December 19, 2025

Reference Number: 25253.01

RE: Transportation Addendum Letter
Proposed Mixed-Use Development
1544 & 1546 Four Mile Creek Road, Niagara-on-the-Lake

Figure 6.7 : Commercial East Elevation

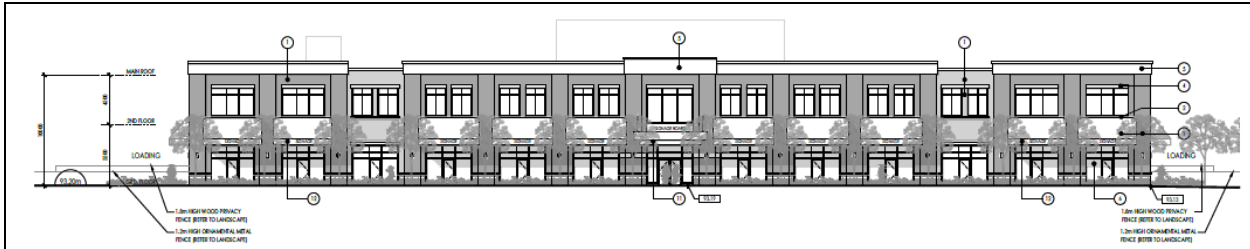
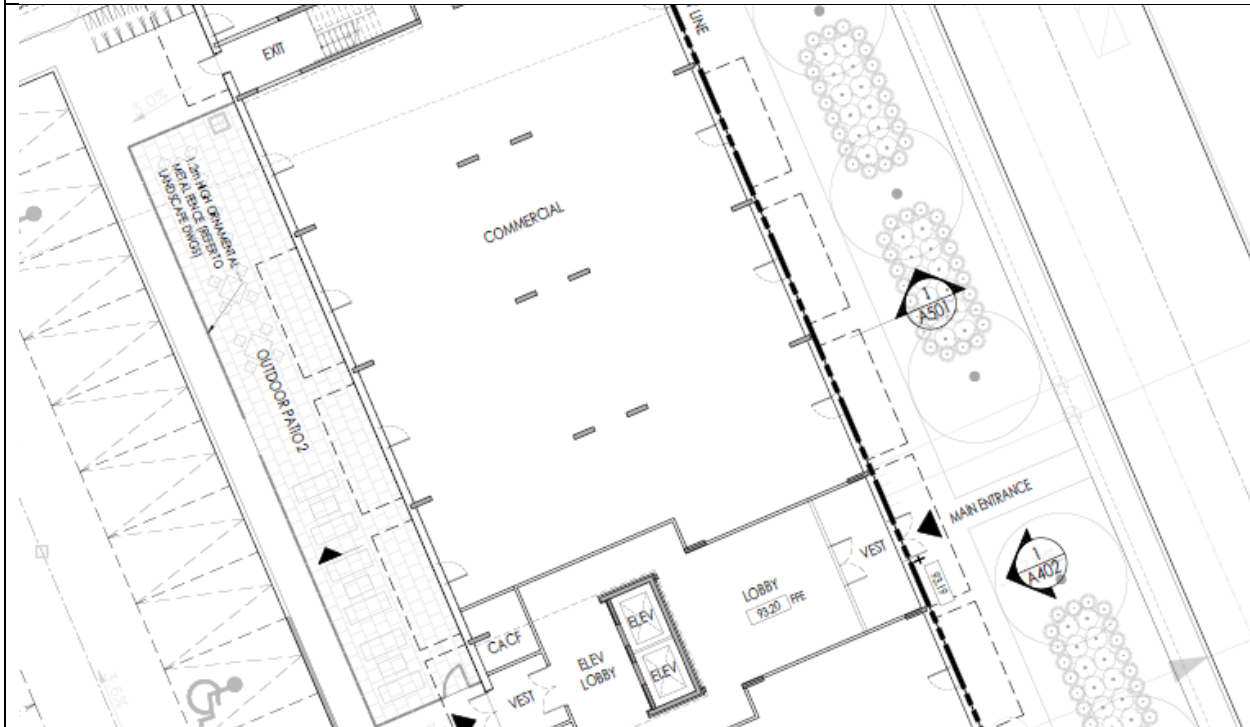
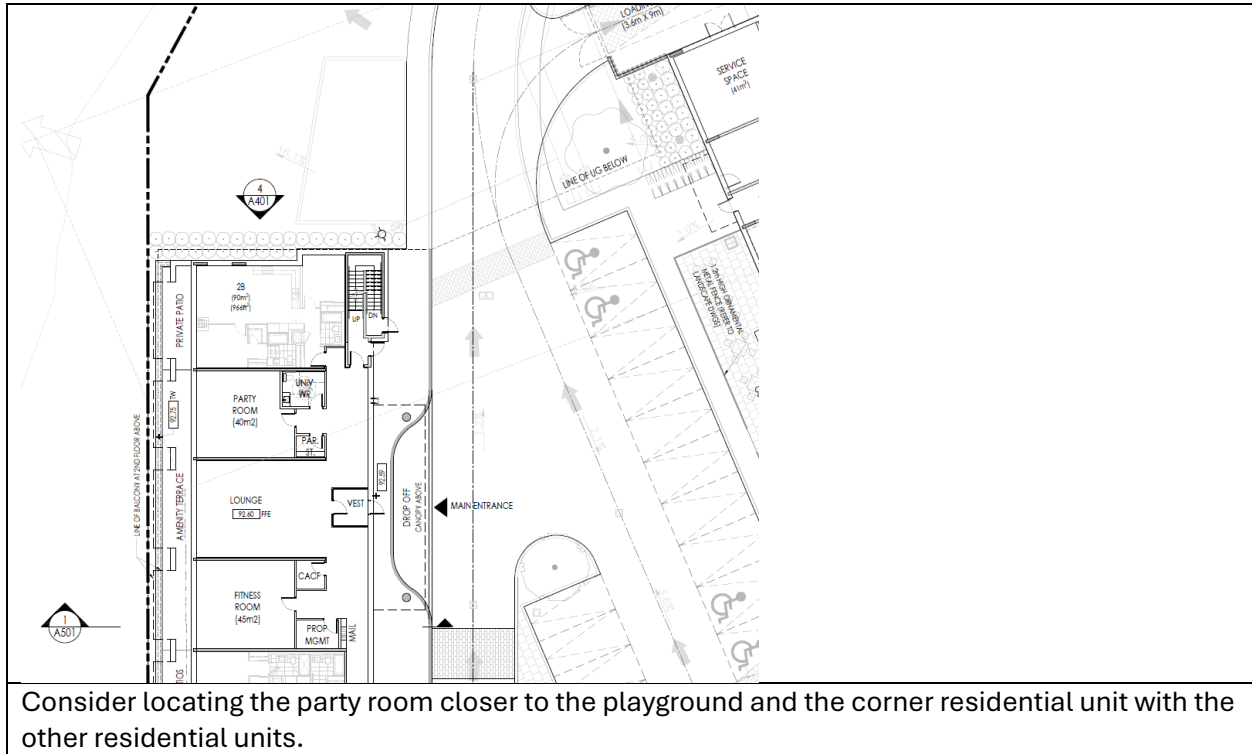
While the overall architectural design approach represents good practice, a further contextual nuance can be added to the architectural design that would help break up the long façade. This can be done simply by variation of exterior materials and colours, variation of the cornicing element,

window sizes etc. This level of variation will enhance visual interest and complement the visual plurality of the streetscape.

Include zoning provisions that seek to ensure that a certain percentage of the façade is glazed with vision glass and not spandrel.

<p>Storefronts of spandrel panels and not vision glazing. These are blank facades that do not help to animate the street. The signage is unharmonious and unattractive.</p>
	<p>Example of a development with vision glazing and well-designed signage.</p>

The Commercial/office building includes awnings which can contribute greatly to visual interest through colour and design. It should be noted that the proposed awnings are within the Regional ROW. The Region may not permit these. Setting the proposed building back 1.0m can provide the necessary space to keep the awnings within the private realm.

Setting the building back 1.0m will also accommodate the exterior swing of exterior doors facing the street.

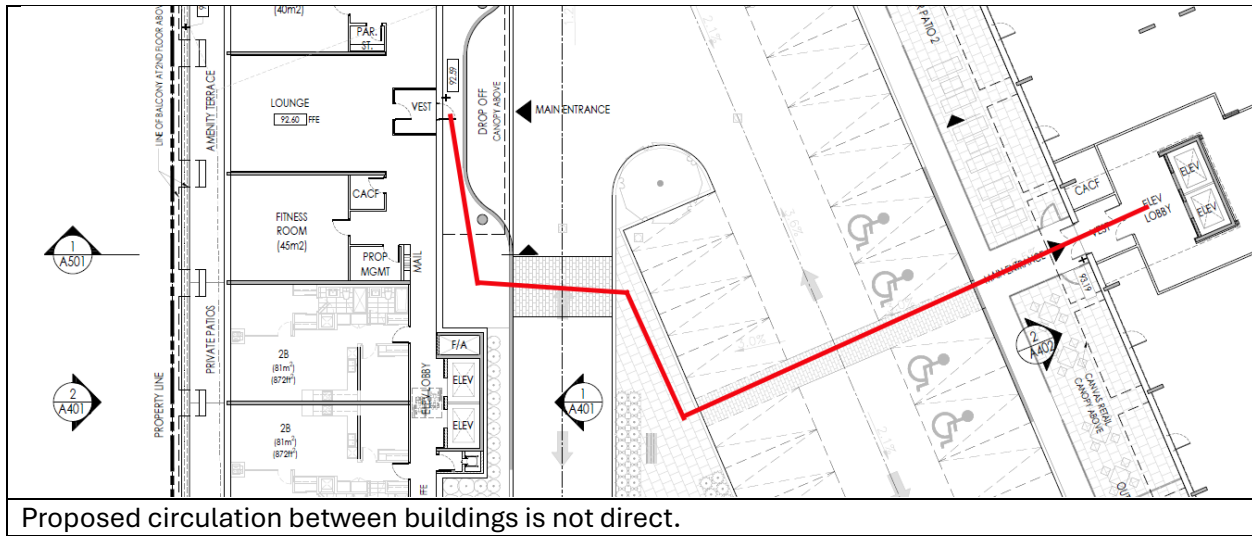
The location of the playground may be compromised with shade. This space will be in shade for prolonged periods. Consider locating the playground or shifting the space north to avoid building shadows.

Consider a more direct and barrier free route from the commercial/office building to the residential building. As proposed pedestrians will take direct desire lines from door to door. The design should better facilitate this and provide a direct route.

Consider additional landscaping along the south east corner of the site by shifting the masonry wall closer to the parking spaces and complementing the wall with planting of a tree and shrubs.

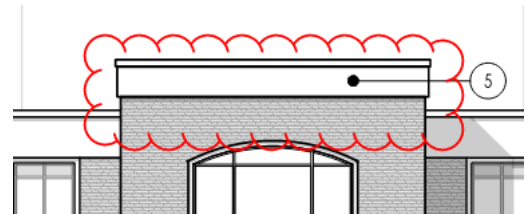
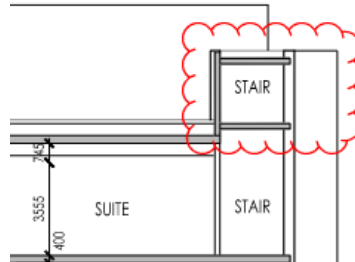
<p>12. Zoning</p>	<p>Parking</p> <p>a) Staff have provided minimum parking standards based on the full extent of the requested uses with the following parking rates:</p> <ul style="list-style-type: none"> i. Restaurant – 1 per 9m² GFLA ii. Medical Office – 1 per 15m² GFLA iii. Outdoor Patio Restaurant – 1 per 30m² GFLA iv. Apartment Building – 1 per unit <p>b) Based on the provided ground floor plan of the commercial building, Staff calculated the leasable floor area (minus the lobby, vestibule and stairways) to be approximately 1,466m². However, Staff note that the final leasable floor area of the commercial uses will be lesser than this, given that there will be additional circulation spaces, storage areas, and washrooms. If using the parking rate for a restaurant for the entire ground floor area, this would necessitate <u>163</u> required parking spaces.</p> <p>c) Similarly, Staff calculated the leasable floor area for the second storey office spaces to be approximately 1,495m², necessitating <u>100</u> required parking spaces for medical office uses.</p> <p>d) Based on 387m² of restaurant patio space, the required parking spaces is <u>13</u>.</p> <p>e) Based on 29 residential units, the required parking spaces for the residential component is <u>29</u>.</p> <p>f) In total, the requirement for parking spaces based on the full extent of the requested uses is <u>305</u>. Based on this number, the site is deficient 105 parking spaces.</p> <p>g) Staff recognize that it is unlikely that the restaurant use will occupy the entire ground floor, and that the medical office use would not occupy the entire second floor of the commercial building. To ensure this, Staff</p>

recommend implementing restrictions on the number of restaurants and medical office uses and their gross leasable floor areas that can be accommodated on-site. Staff also note that there are four (4) outdoor patios, so it is assumed that there would be more than one restaurant.

part of the restriction will be: No Restaurant, and Medical Office.

let's inquire with Craig if shoring is required. If Not we can extend P1 to the property line.

Figure 6.7 : Commercial East Elevation

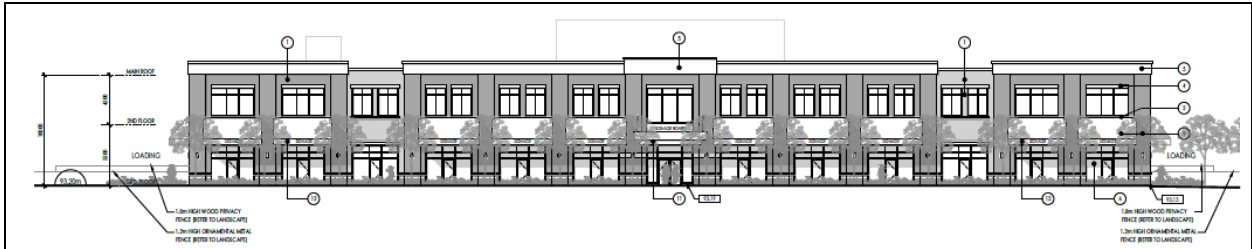
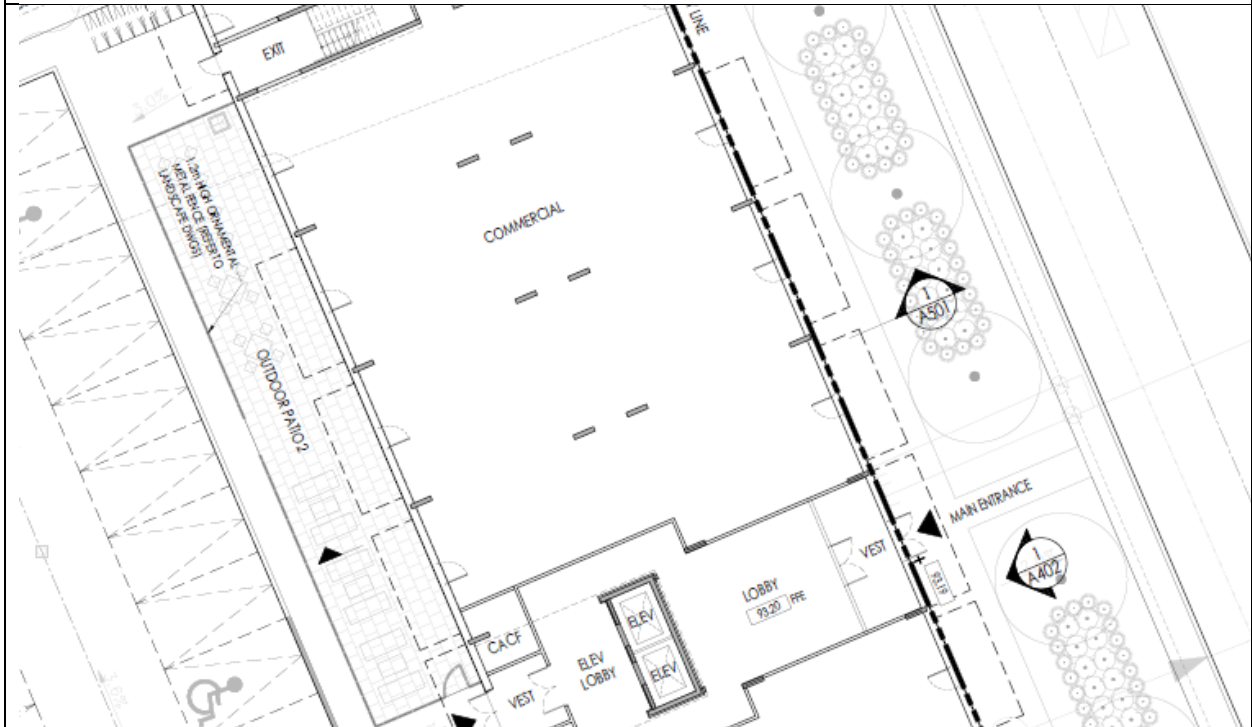
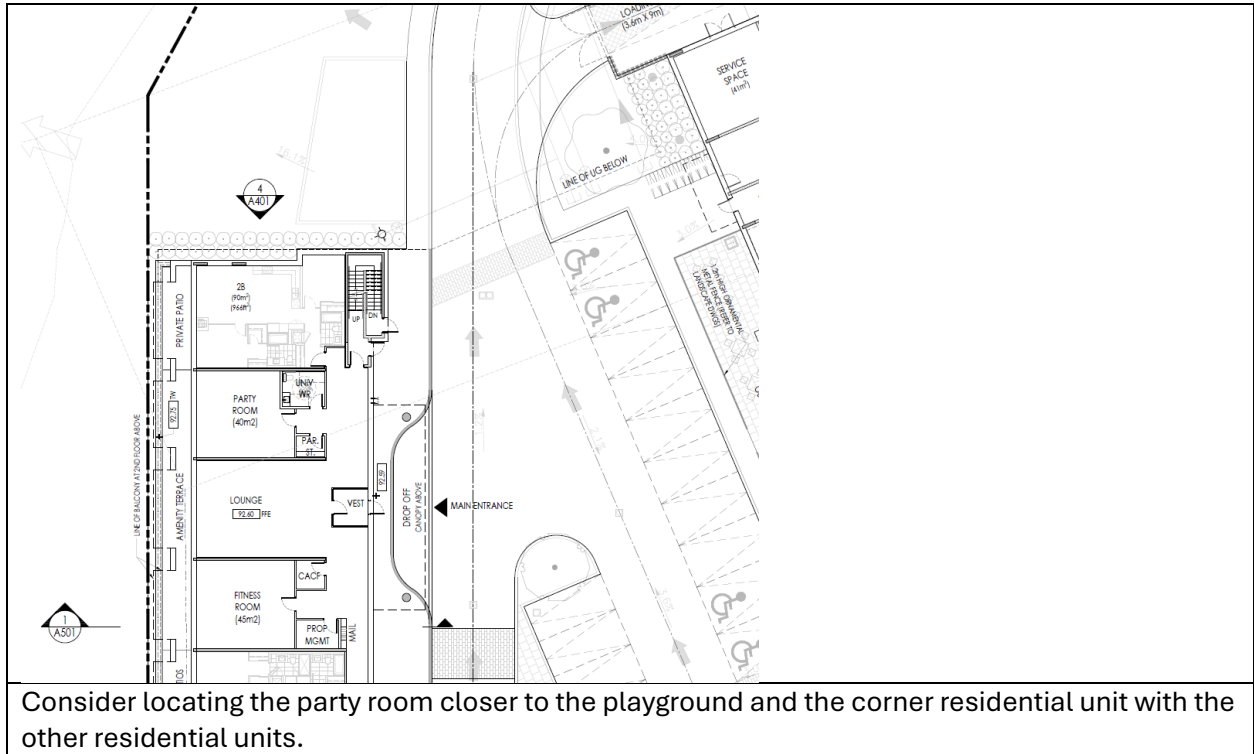
While the overall architectural design approach represents good practice, a further contextual nuance can be added to the architectural design that would help break up the long façade. This can be done simply by variation of exterior materials and colours, variation of the cornicing element,

window sizes etc. This level of variation will enhance visual interest and complement the visual plurality of the streetscape.

Include zoning provisions that seek to ensure that a certain percentage of the façade is glazed with vision glass and not spandrel.

<p>Storefronts of spandrel panels and not vision glazing. These are blank facades that do not help to animate the street. The signage is unharmonious and unattractive.</p>
	<p>Example of a development with vision glazing and well-designed signage.</p>

The Commercial/office building includes awnings which can contribute greatly to visual interest through colour and design. It should be noted that the proposed awnings are within the Regional ROW. The Region may not permit these. Setting the proposed building back 1.0m can provide the necessary space to keep the awnings within the private realm.

Setting the building back 1.0m will also accommodate the exterior swing of exterior doors facing the street.

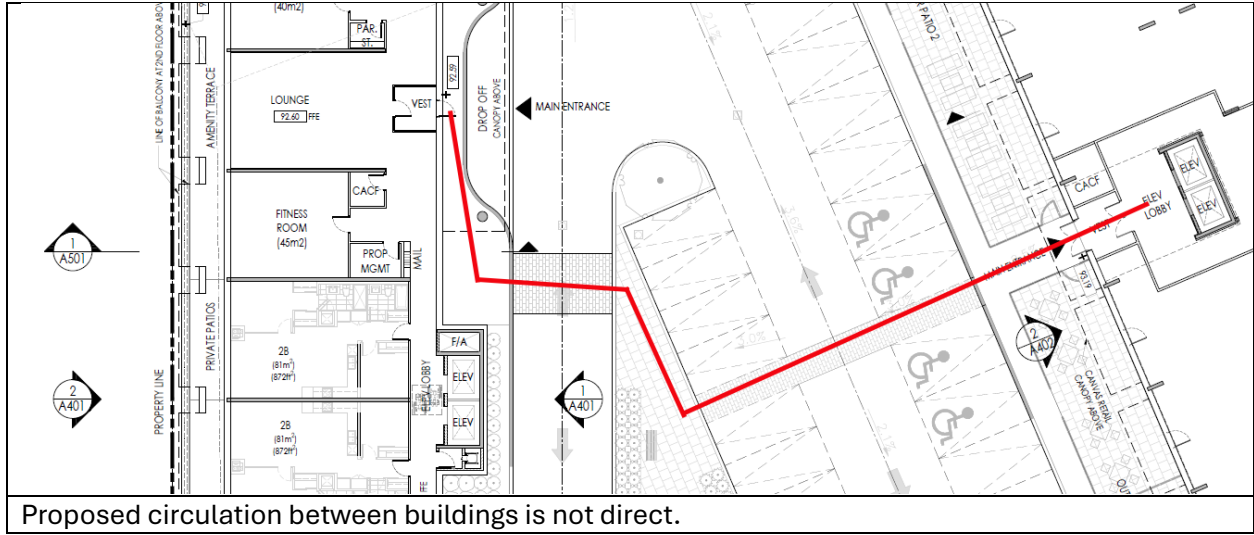
The location of the playground may be compromised with shade. This space will be in shade for prolonged periods. Consider locating the playground or shifting the space north to avoid building shadows.

should Region allow it we would be happy to do so.
